CONTRACT TITLE: PW 5 FULTON TRANSIT IMPR FULL TITLE: PW 5 Fulton Transit Improvements

Subject: CMD Recommendation Memo: Sourcing Event: 0000006630 - PW 5 Fulton Transit

Planning Department Case Number: 2011.0558E

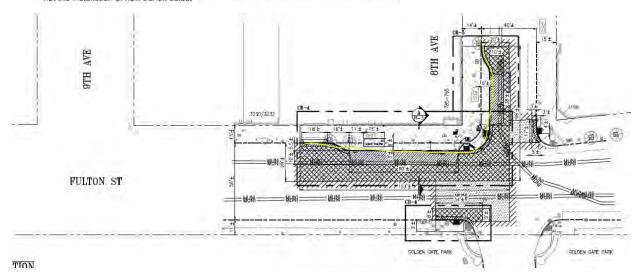
At 8th/Fulton – there was an added transit bulb scope on the 8th side requested by MTA during design, description below shows one 100-bulb on Fulton side, and miss the other bulb on 8th side.
